P.U.D. PLAN (#07-011A)  
FOR  
ANAQUA RANCH UNIT I-B, PUD  
BEXAR COUNTY, TEXAS

January 21, 2009

Re: **Anaqua Ranch I-B (Amendment)**

**PUD # 07-011A**

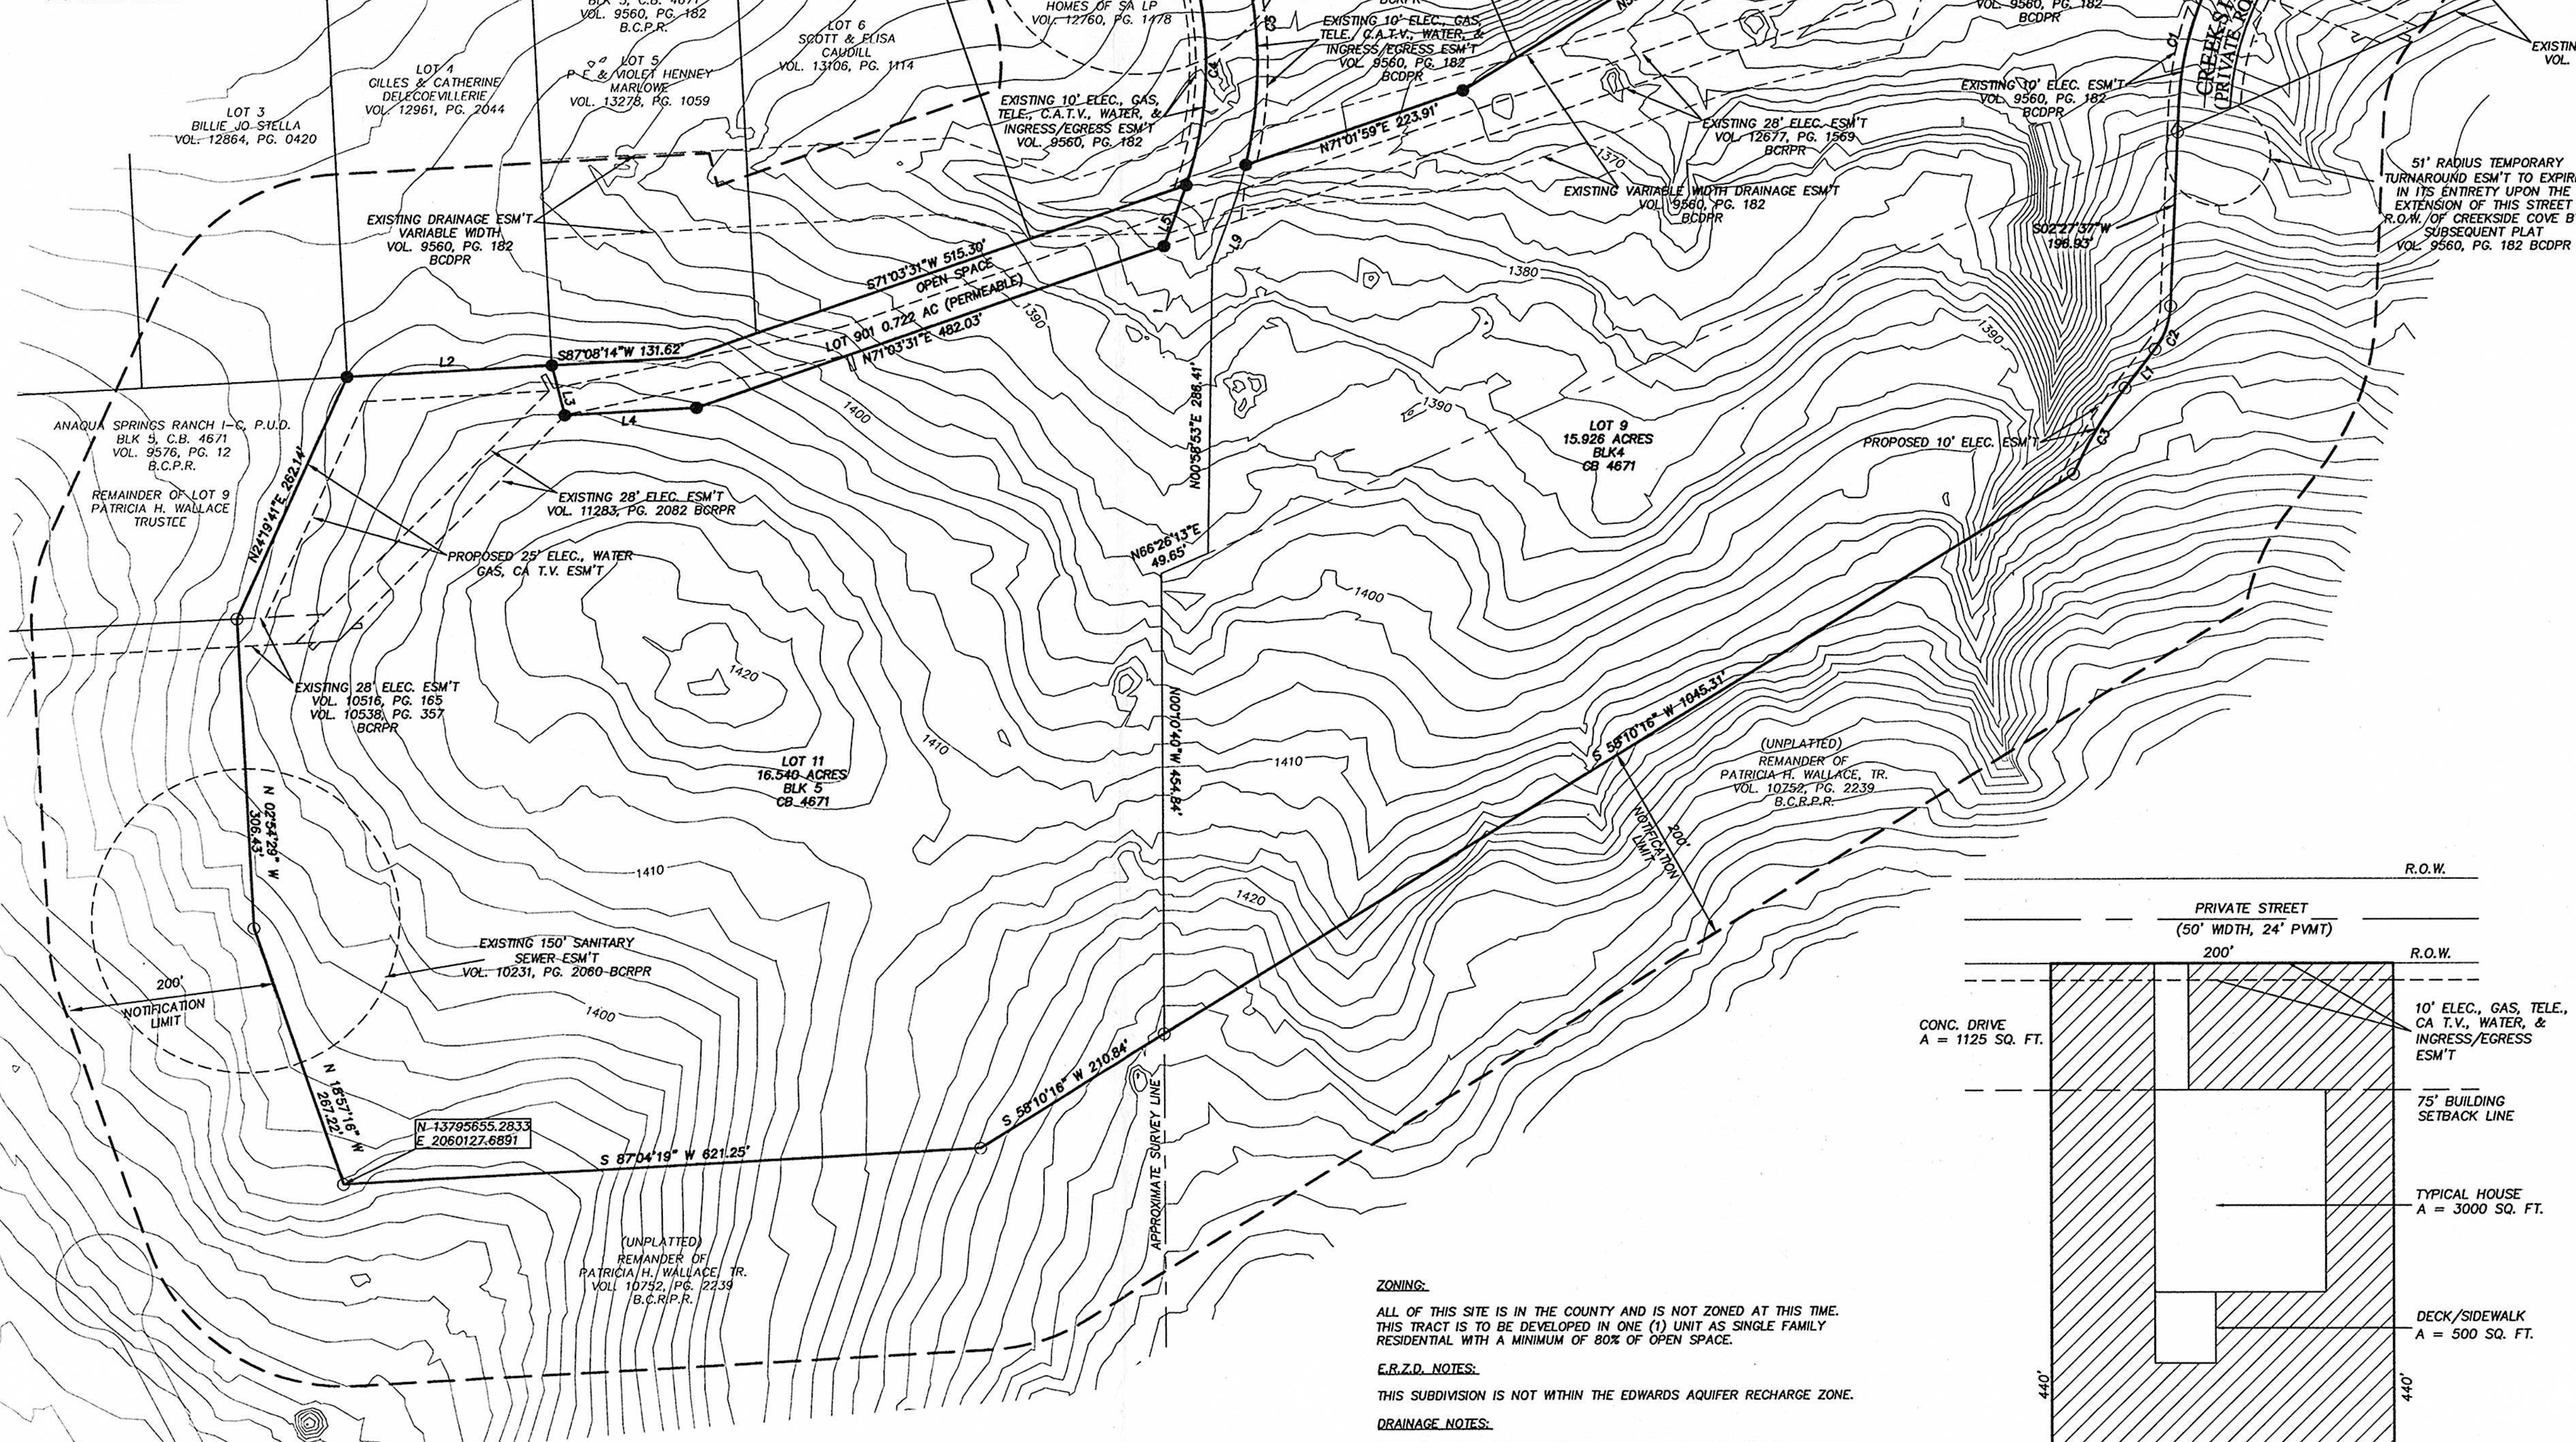
**SAWS Aquifer Protection and Evaluation** approves with the following conditions:

In accordance with the Aquifer Protection Ordinance No. 81491 for Plat Certification, the following conditions shall be met:

- 100 year Flood Plain Shown and Buffering (if applicable)
- Significant Recharge Features and Buffering (if applicable)
- Category Letter for All Site Specific Plats (if Category 2 or 3, an Aquifer Protection Plan is required) (if applicable)
- A Water Pollution Abatement Plan or Contributing Zone Plan must be submitted to and approved by the Texas Commission on Environmental Quality (TCEQ) prior to construction.
- According to the CZ Plan (SAWS # 1583) and the Aquifer Protection Ordinance #81491 Sections 34-914 buffering may be required. In some places up to 100 feet. Any existing abandoned or substandard wells on the site should be plugged by the property owner in accordance with SAWS regulations and standards.

Department of the Army has cited that this property is located within the five (5) mile Camp Bullis Awareness Zone and the Garrison Commander has the following response. "Our concerns on compatibility with Camp Bullis will be addressed so long as the developer:

- Has appropriate documentation - recent surveys (not older than three (3) years conducted by a professional biological consultant IAW USFWS protocols showing that no endangered species are present and sends the surveys to USFWS Ecological Services Office in Austin. Contact Allison Arnold with U.S. Fish and Wildlife at ([allison\\_arnold@fws.gov](mailto:allison_arnold@fws.gov)) or 512-490-0057 ext. 242 for additional information concerning the survey requirements.

It will be expected that all of the property depicted in the Planned Unit Development Amendment including but not limited to floodplains, drainage areas, and open space shall be platted. All platting shall comply with the Unified Development Code (UDC), the City's Master Plan, Major Thoroughfare Plan, and all applicable regulations for the City of San Antonio.
